Airport *Link*

environmental impact statement
supplementary report

Airport Link Environmental Impact Statement Supplementary Report

The figure below shows these key markets over a map of Brisbane.

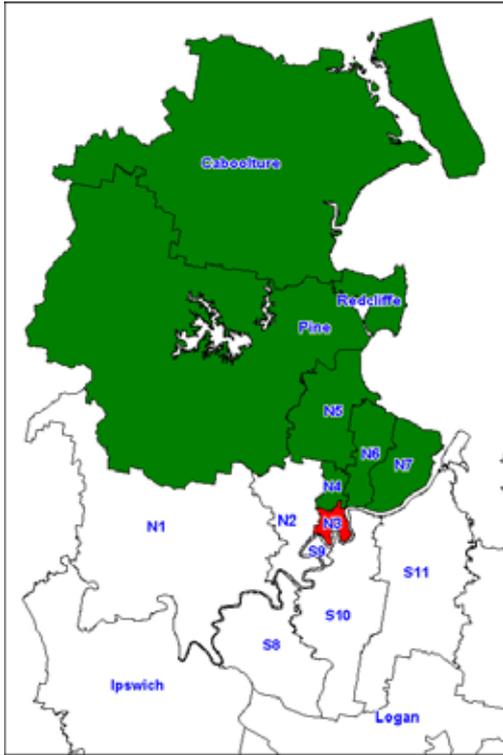
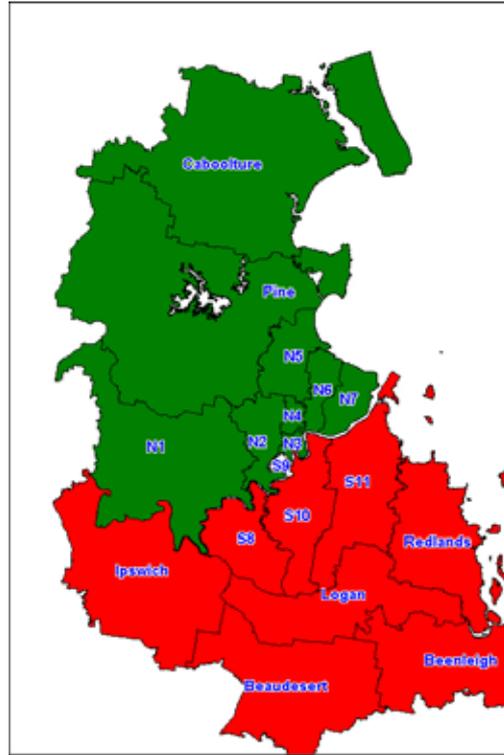
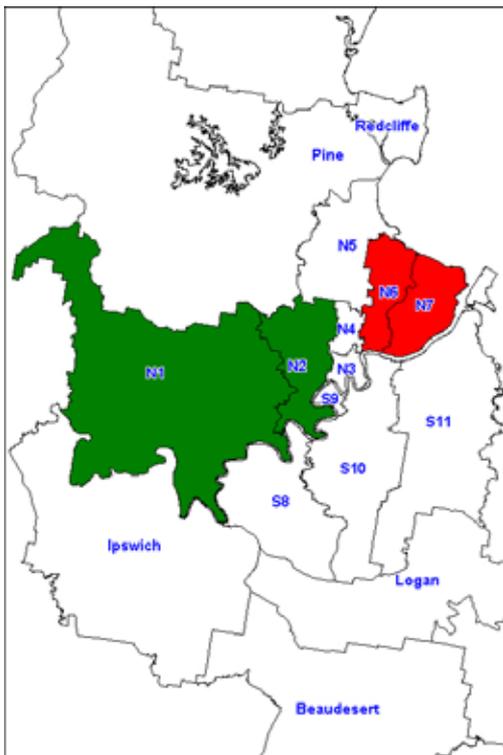
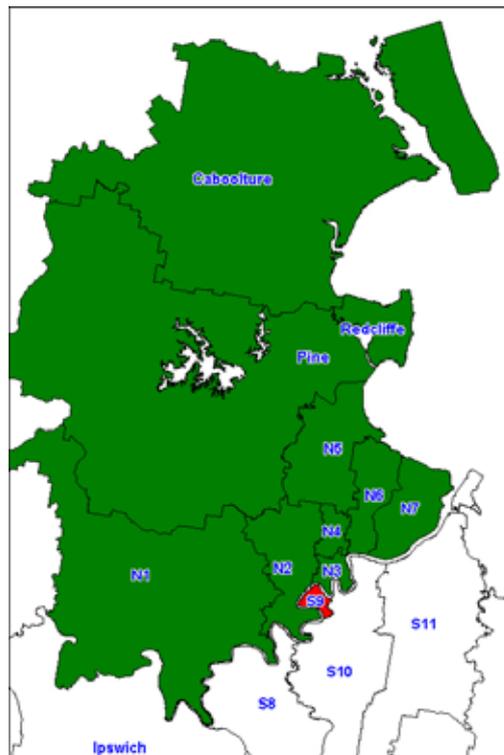
A statement to clarify the origin of the residents in the user preference survey would be useful.

The user preference survey was designed to survey a sample of Brisbane residents making the types of trips that could potentially be suited to toll road use. The survey quotas were divided into trip categories to target specific areas of interest including persons who had direct and recent experience of a journey through the corridor of interest.
